Clonburris SDZ, Reg ref: SDZ22A0010
Dublin 22

Ronan Mac Diarmada & Associates
Landscape Architects & Consultants

**CLARIFICATION OF ADDITIONAL
INFORMATION RESPONSE**

March 2023

Green Corridor Plan & Extract from : Clonburris SDZ, Parks & Landscape Strategy by DFLA

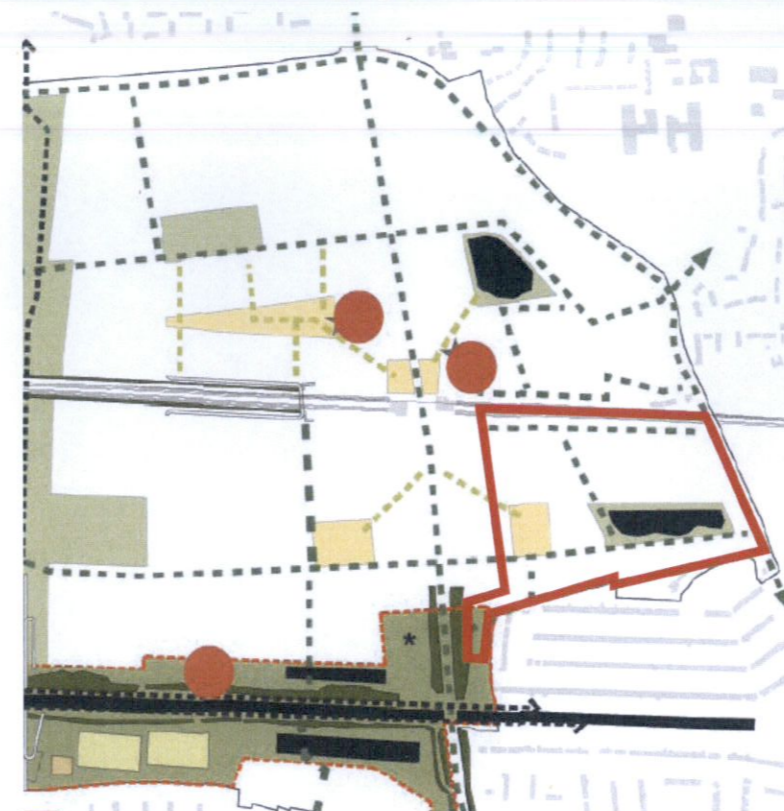
(b) A Strategic Green Corridor facilitated along the northern boundary of the site adjacent to the Dublin-Cork Railway.

(b) As per Extract from : Clonburris SDZ, Parks & Landscape Strategy by DFLA, We are proposing to enhance the planting along the northern boundary of the site, linking the Grand Canal Corridor.

We propose a native hedge & whip planting running along the north-east boundary. This will help enhance the biodiversity along this corridor and will also introduce a new local green corridor to the site and the railway line.

In co-ordination with Irish Rail, we are proposing a low wall and railing between the boundary to the north and the corridor. This will allow passive surveillance and also provide pedestrain links to the rail line and the site.

Proposed Local Green Corridor & Indicative Section

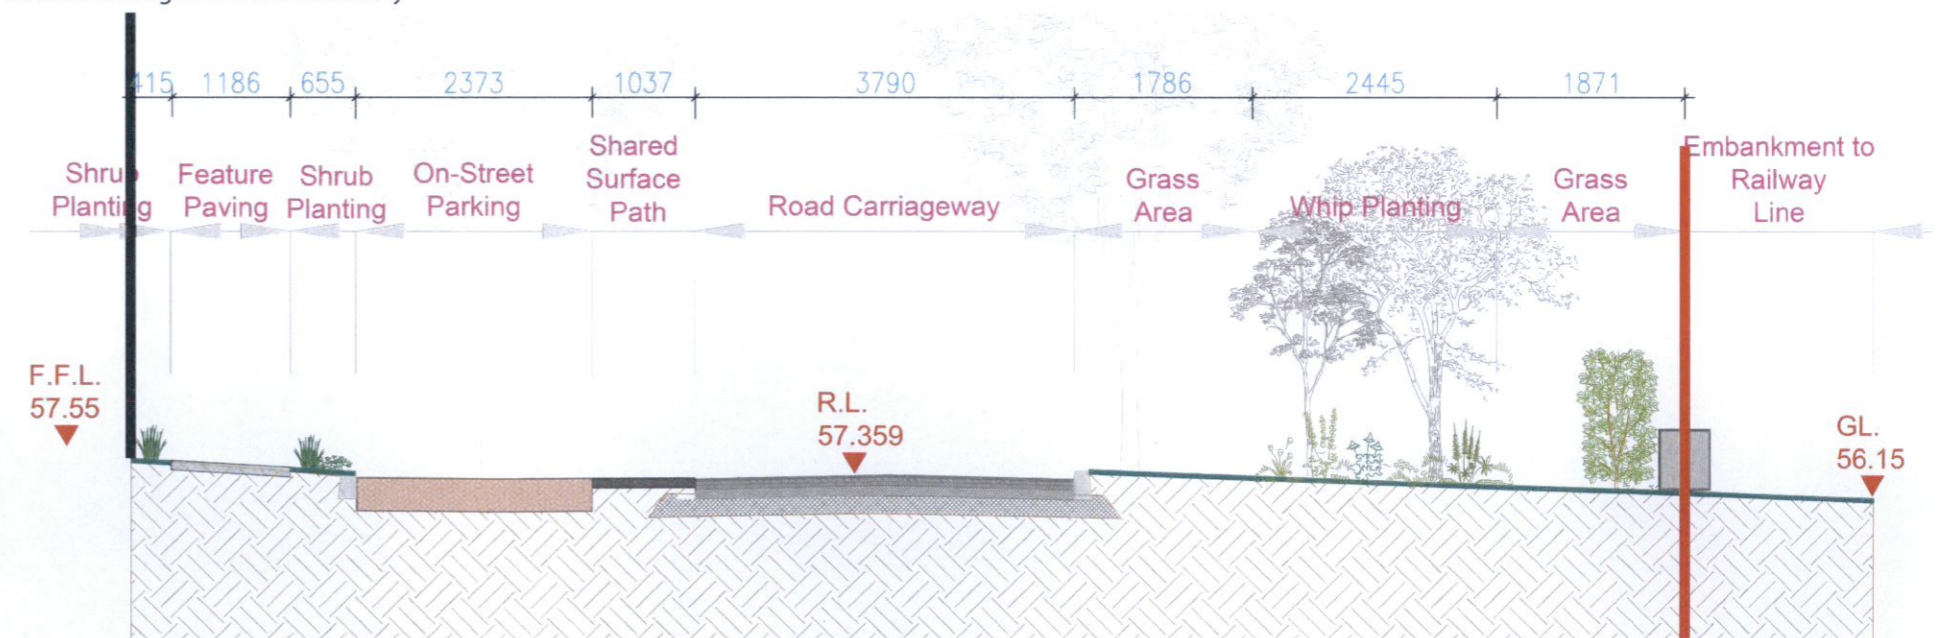
(b) A Strategic Green Corridor facilitated along the northern boundary of the site adjacent to the Dublin-Cork Railway.

(b) Also, please refer to whip planting list for details and location of planting and section shown on below for typical treatment through Northern Boundary.

New Local Green Corridor & Green Link Plan

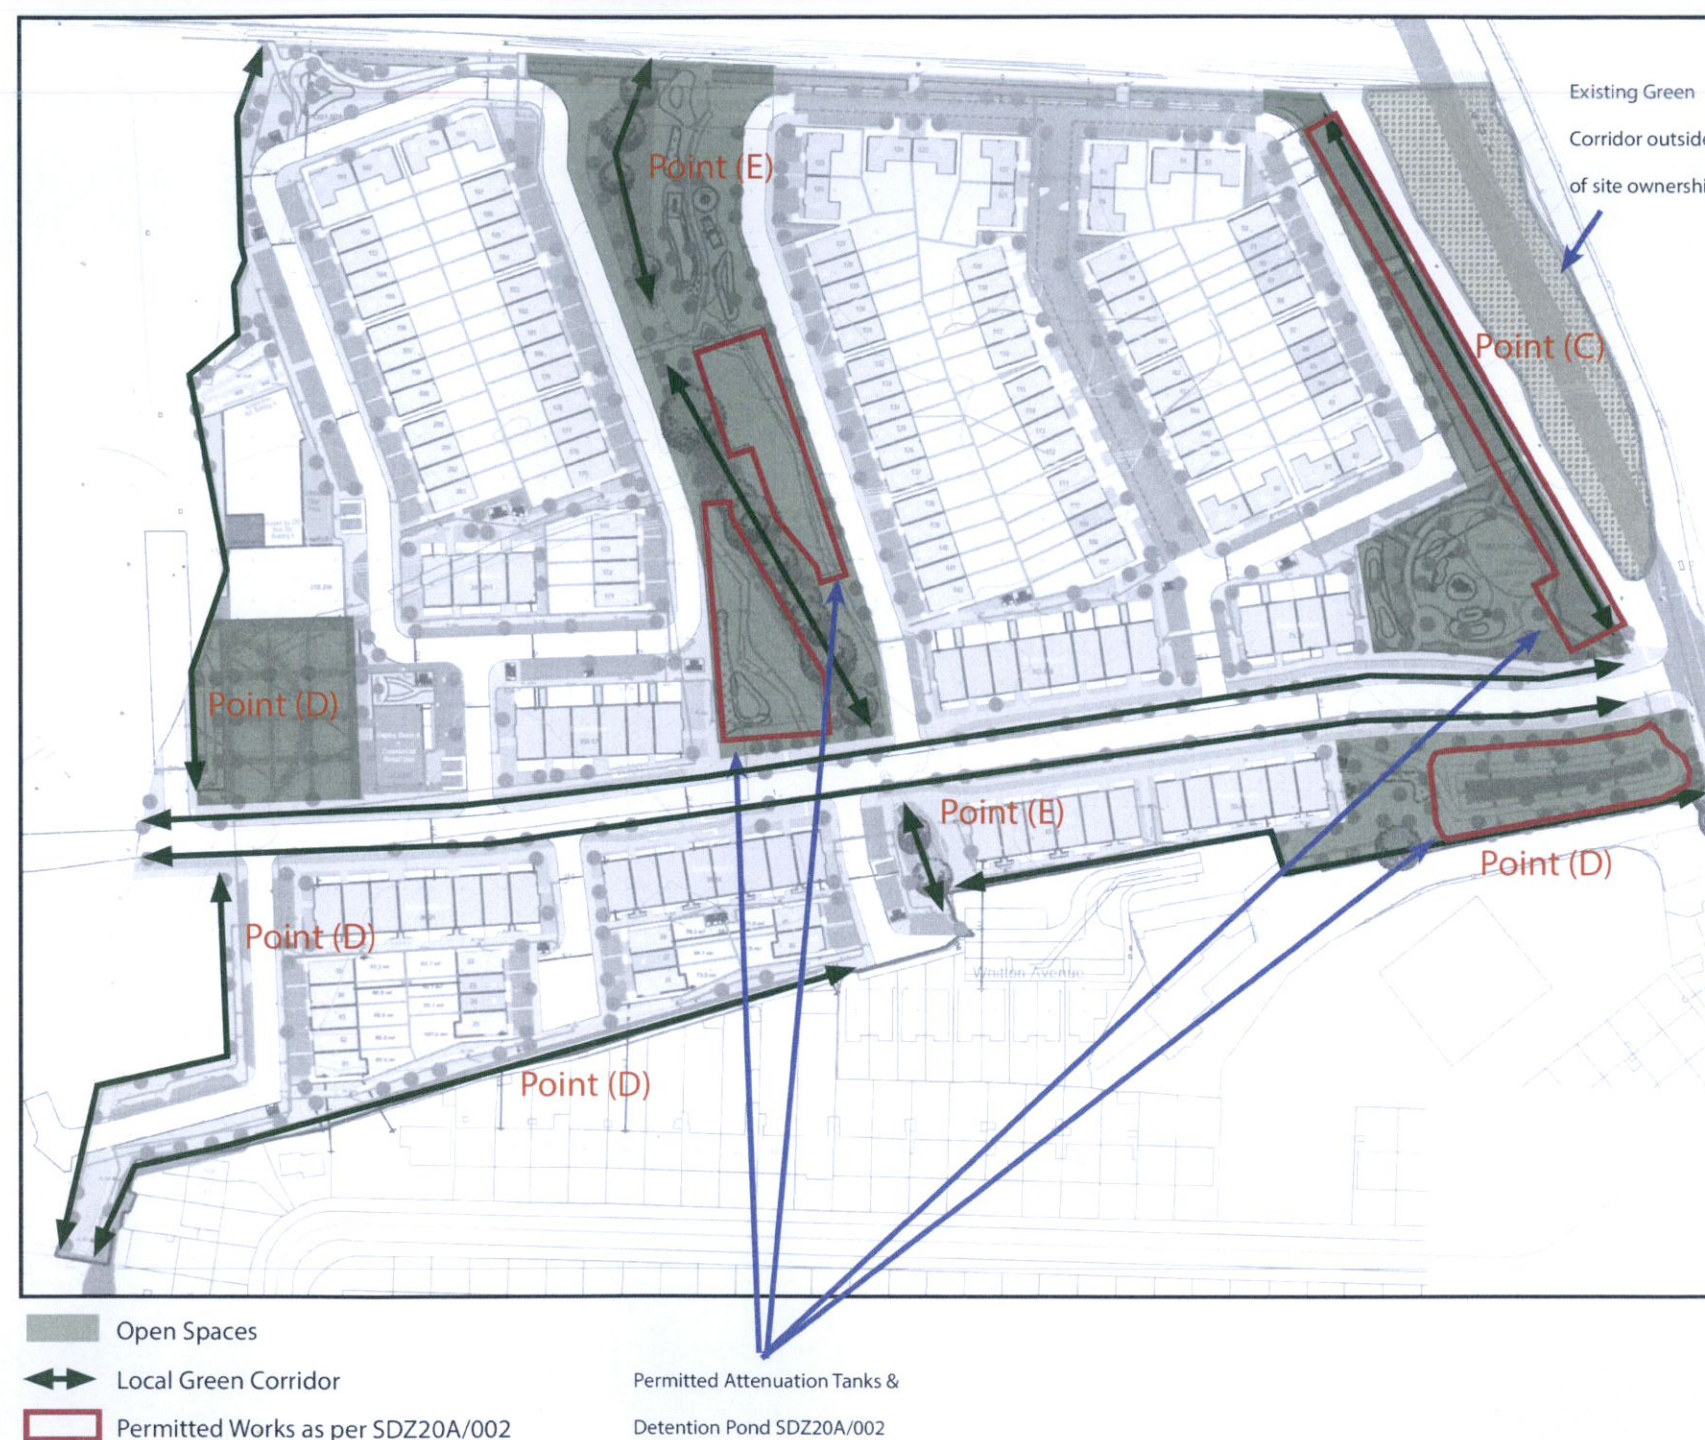
(c) A Local Green Corridor approximately N-S along the eastern boundary incorporating nature based SuDS: planting proposals require strengthening as there is no difference between it and the tree planting proposed on the other local streets and homezones.

(d) A Local Green Corridor approximately N-S and E-W along the westernmost local street south of Clonburris Link Street incorporating nature based SuDS: planting proposals require strengthening as there is no difference between it and the tree planting proposed on the other local streets and homezones.

(e) A Local Green Corridor approximately N-S through the centre of the development increasing the retention of trees and hedgerows;

(c) Due to restrictions from previously agreed attenuation tanks in this area, we have proposed the use of wildflower planting and native hedge planting along the Eastern Boundary to introduce a new Local Green Corridor to mirror the Existing Green Corridor. Street tree planting will line the road.

(d) The Green corridor located N-S and E-W has been supplemented by the use of wildflower planting and native hedge planting. The tree planting has been revised to include native tree species, to differentiate it from local streets and homezones.

(e) The local green corridor running N-S through the centre of the development is relatively untouched, SDCC infrastructure walls, attenuation are located in this area. We wish to retain this hedgerow as much as possible, subject to SDCC Works . Part of the hedge has been removed due to the agreed link road running East - West (Distributor Road as prescribed by SDCC) through the site and some trees will be removed as per Arborist recommendation.

New Local Green Corridor & Green Link Plan

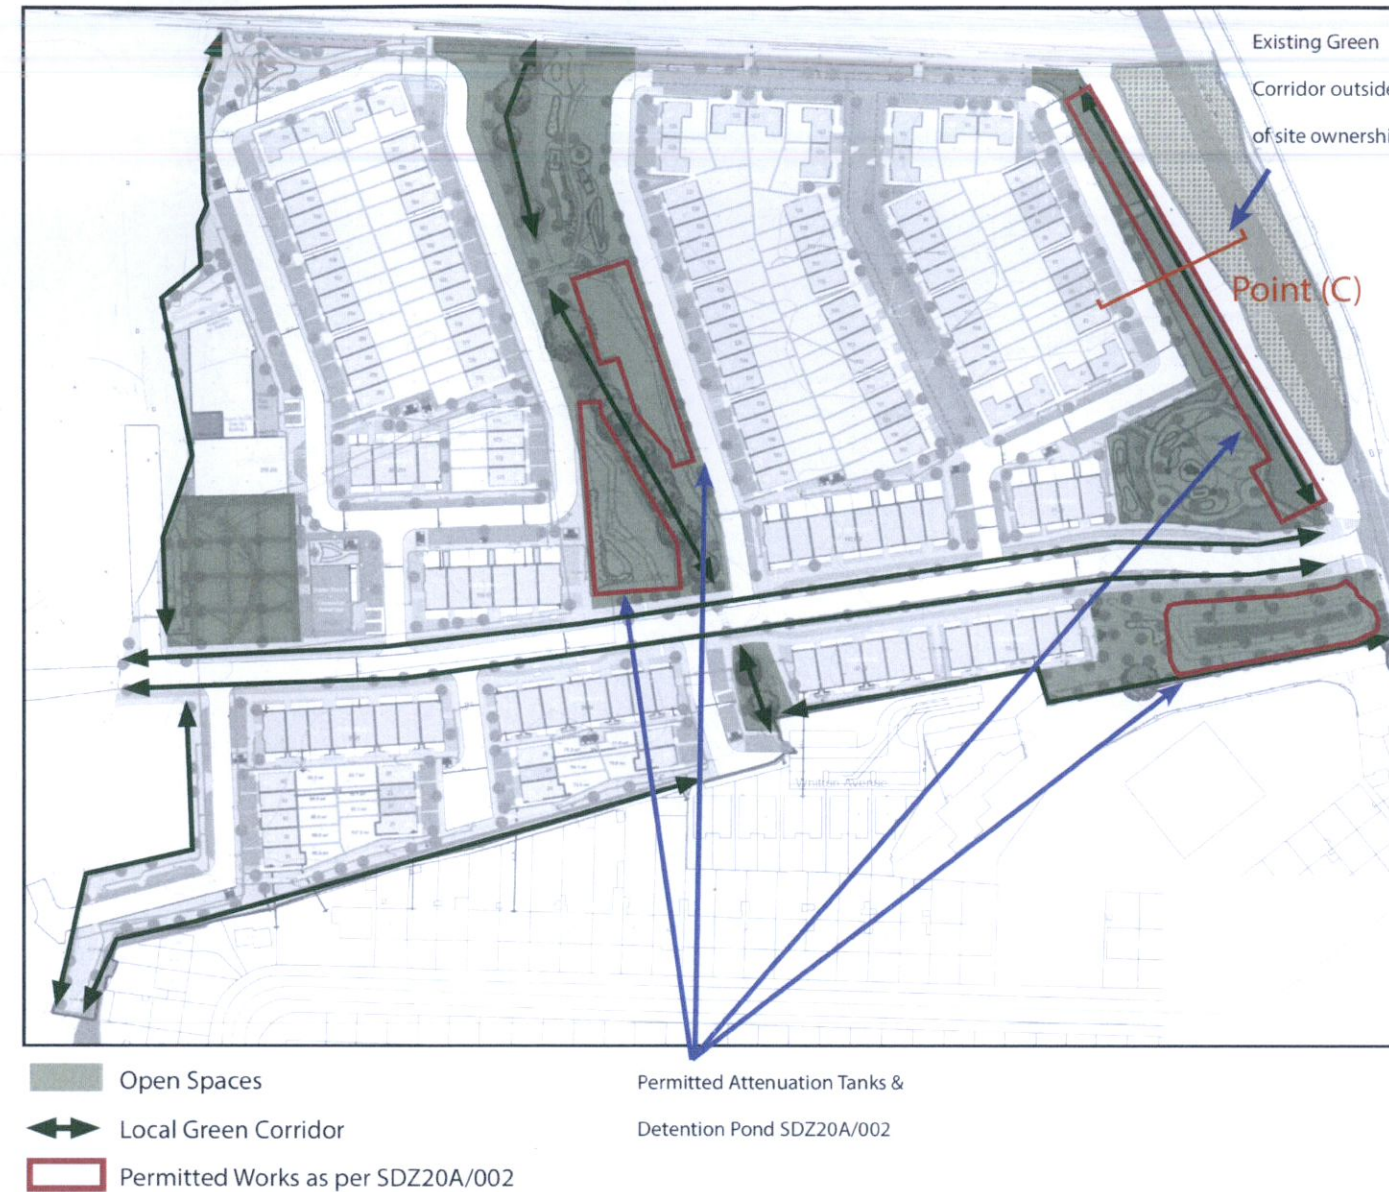
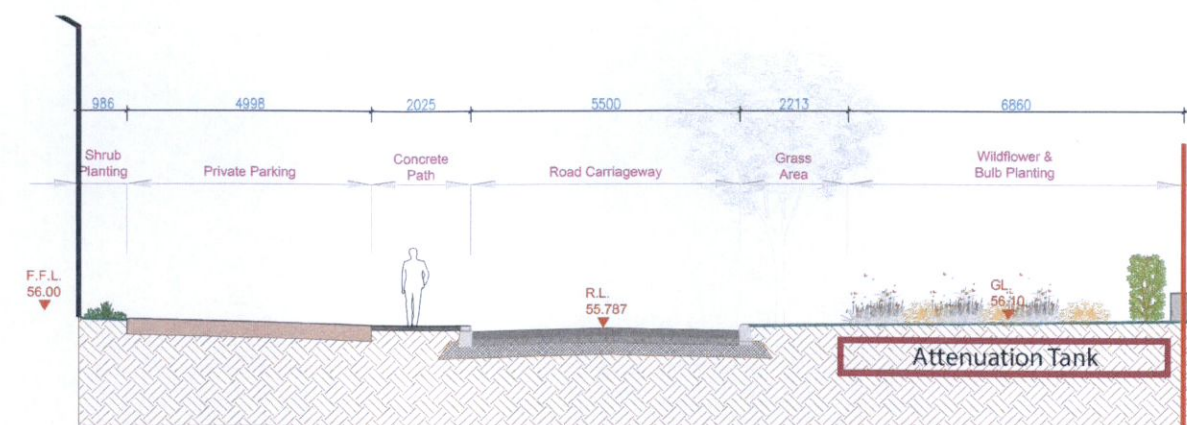
(c) A Local Green Corridor approximately N-S along the eastern boundary incorporating nature based SuDS: planting proposals require strengthening as there is no difference between it and the tree planting proposed on the other local streets and homezones.

(c) Due to restrictions from previously agreed attenuation tanks in this area, we have proposed the use of wildflower planting and native hedge planting along the Eastern Boundary to introduce a new Local Green Corridor to mirror the Existing Green Corridor. Street tree planting will line the road and the tree types have been changed to differentiate between the road & Open space.

Nature based SuDS shall be incorporated within the open space south of the distributor road. An attenuation pond with associated planting shall be developed here.

The proposed green corridor will help enhance the existing green corridor located outside the site boundary.

New Local Green Corridor & Green Link Plan

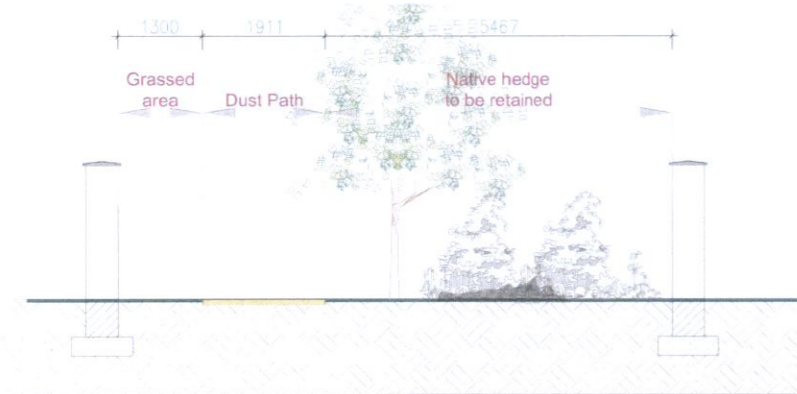
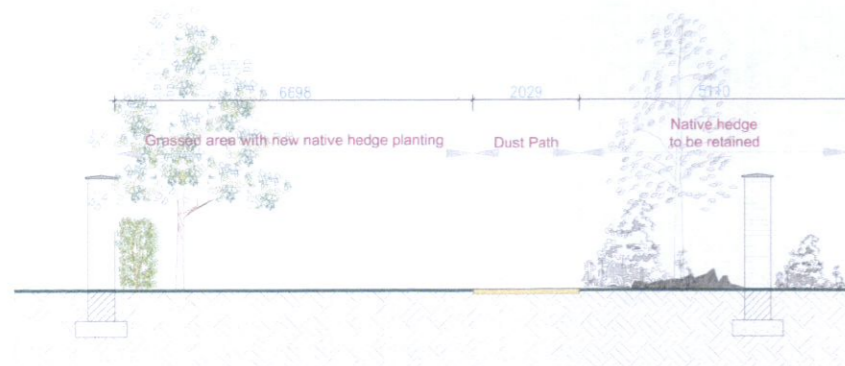
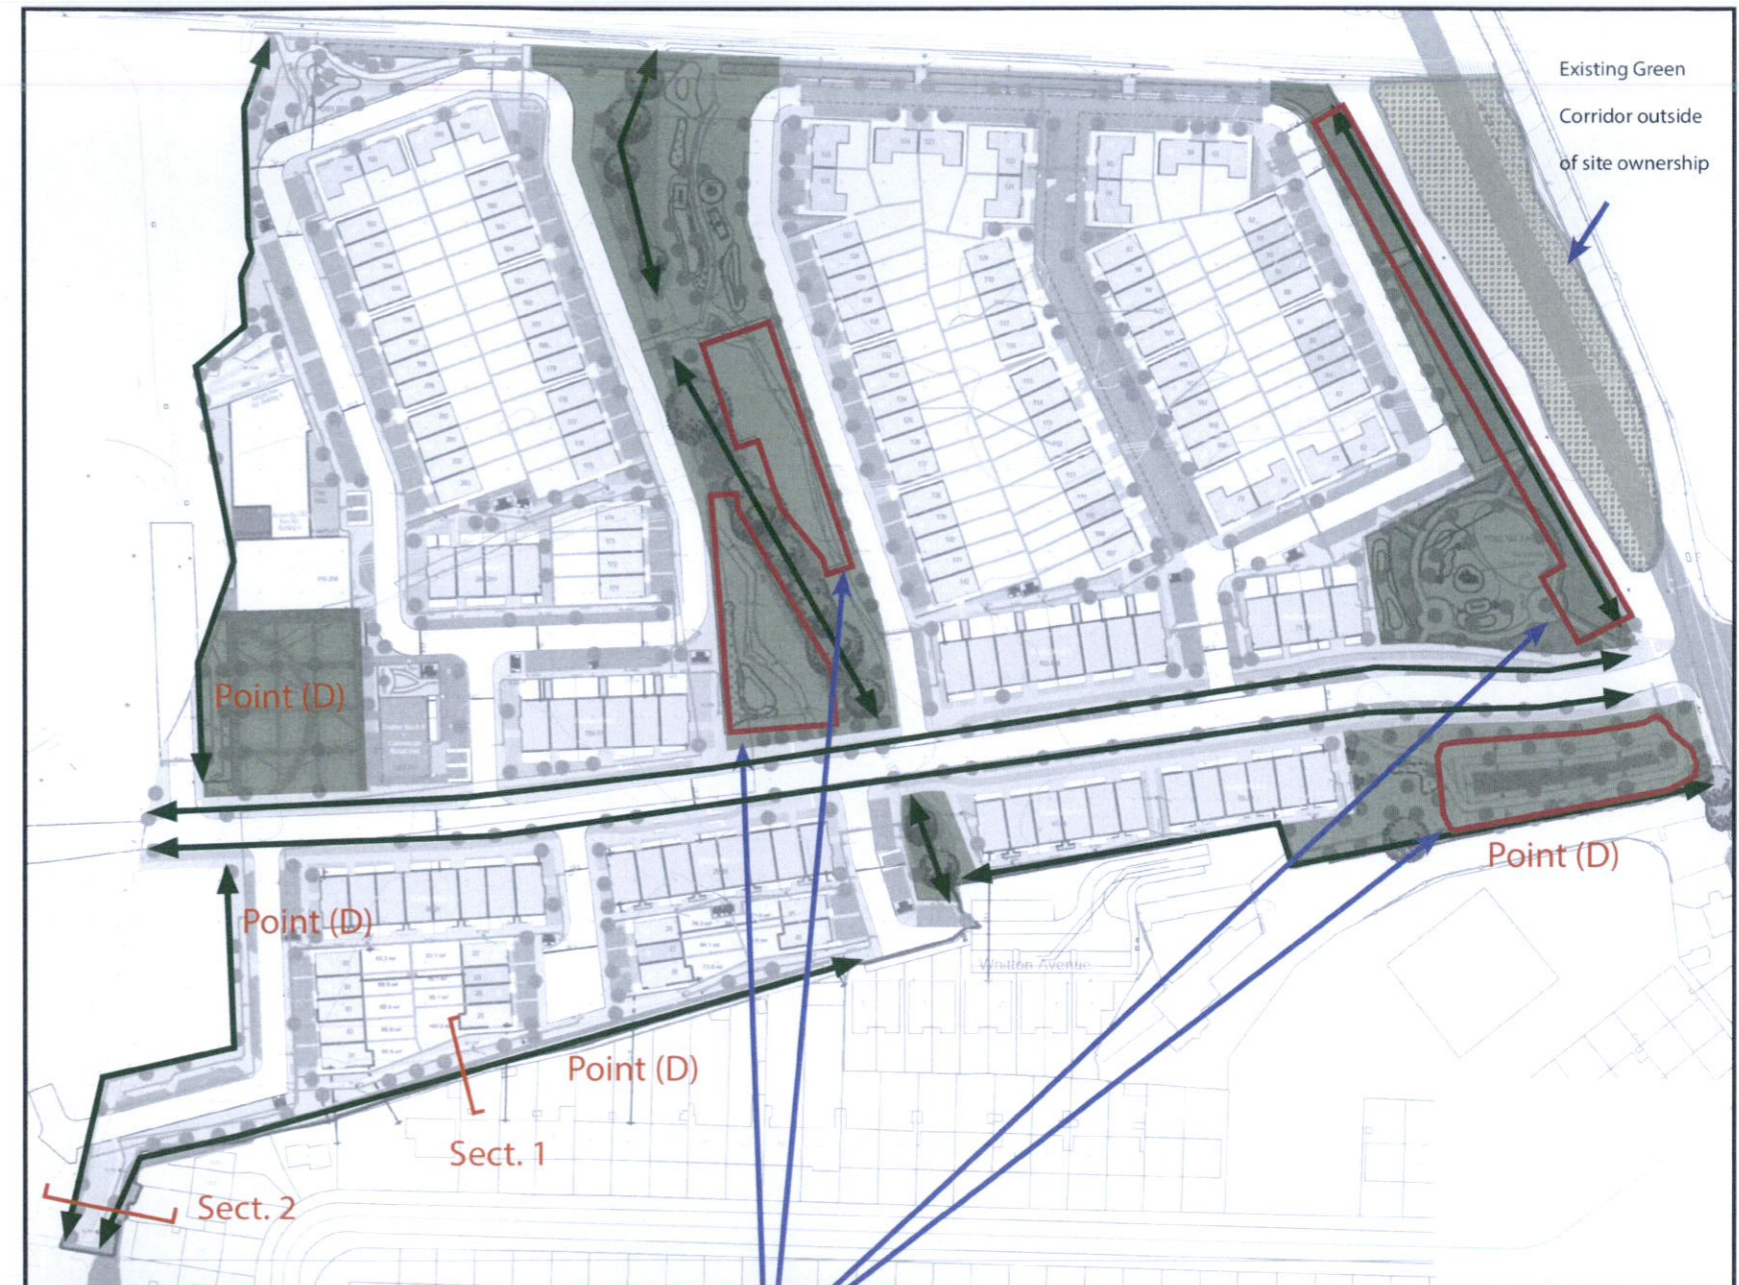
(d) A Local Green Corridor approximately N-S and E-W along the westernmost local street south of Clonburris Link Street incorporating nature based SuDS: planting proposals require strengthening as there is no difference between it and the tree planting proposed on the other local streets and homezones.

(d) The Green corridor located N-S and E-W has been supplemented by the use of wildflower planting and native hedge planting. The tree planting has been revised to include native tree species, to differentiate it from local streets and homezones.

The trees shall be selected to be native and not be overshadowed by the proposed houses, a betula species has been selected as a tree.

The hedge shall be native and whitethorn shall be the principal hedge.
